Dear David,
Re: Proposed Remodelling of Chapel Hall.

Long Rafter Length - Rear Roof over Toilets.

Rear Roof over Toilets - Short Term Problem.

See attached sketch.

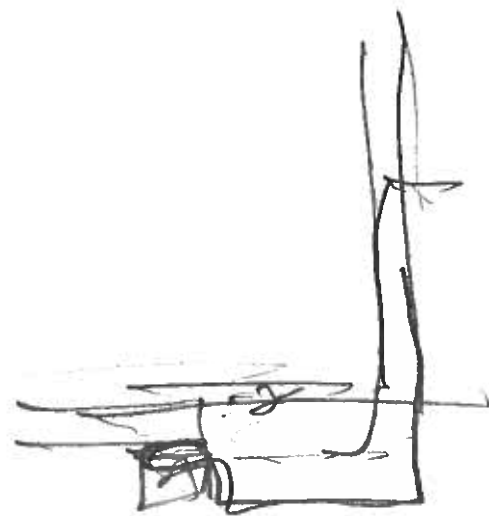
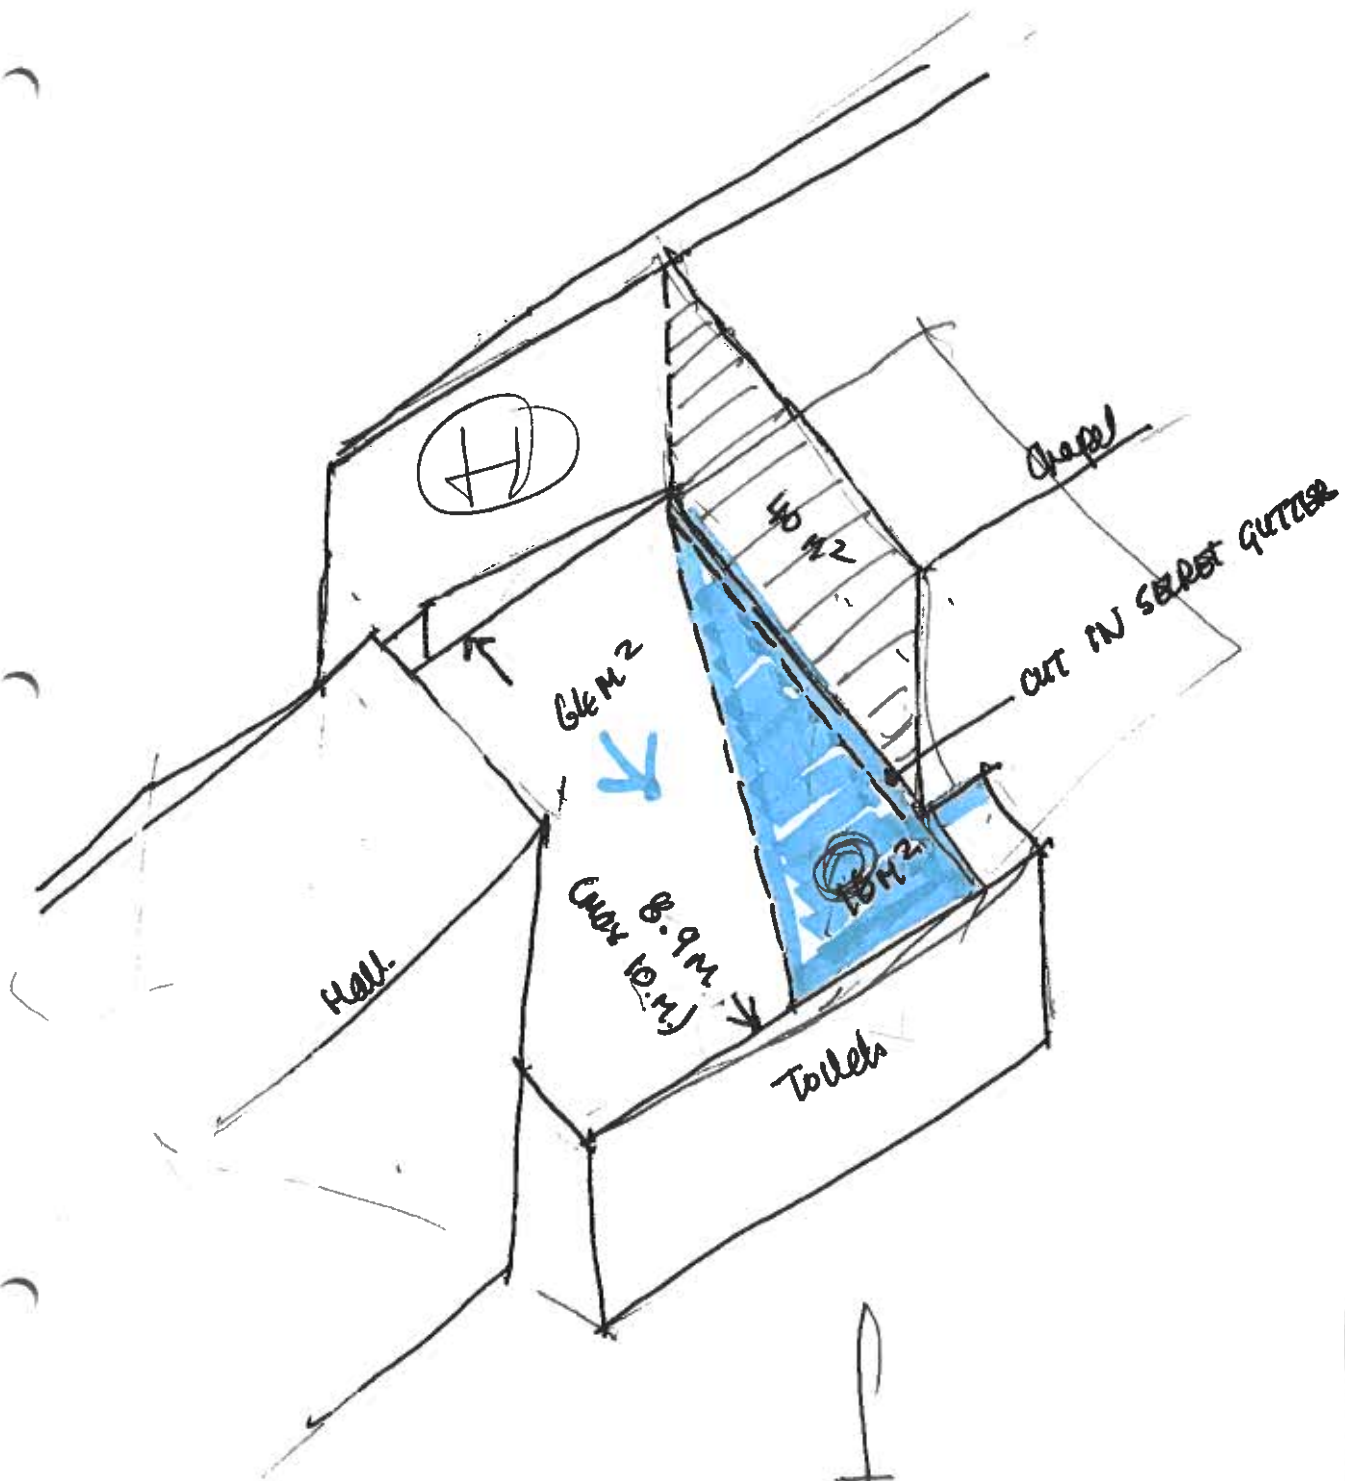
In a storm rainwater is hitting the high gable wall of the chapel which acts as a vertical roof throwing water back onto the main roof. The rear toilet roof is an area of some 64 m² the adjacent wall above this roof is 40 m². The roof is thus asked to drain 104 m² which would greatly extend a theoretical rafter length. The problem is compounded as the wall water is then concentrated onto a triangular quarter of the roof. Thus, water from 40 m² runs over 16 m² of roof already carrying its own storm water.

The new waterproof paint skin on the gable wall has probably exasperated the problem as water is now sheeting off where previously it soaked into the wall.

If a secret valley abutment flashing had been used, then the problem may not have occurred.

If the 16.9 degree upper roof had to stay, we could cut a secret lead valley down the adjacent gable walls, although it would need to be wide enough to carry the volume of water and thus be not 'secret'.

Although 8.9 m rafter length on a south west storm facing roof in Merthyr is still to close the maximum allowed 10 m rafter length. I advise that the existing 16.9-degree roof be replaced and there are two alternatives:

1. Roof as a pitched Hip Roof. See drawings 05D, 06B & 07A.
2. Roof as a pitched roof and a lower flat roof. See drawings 05C, 06A & 07.

Both solutions would need a secret valley. The roof design chosen will obviously be down to cost and Listed Building Consent. I also propose to use Velux daylight tubes – see attached details. Hopefully, the planning application will acknowledge the benefit of daylight.
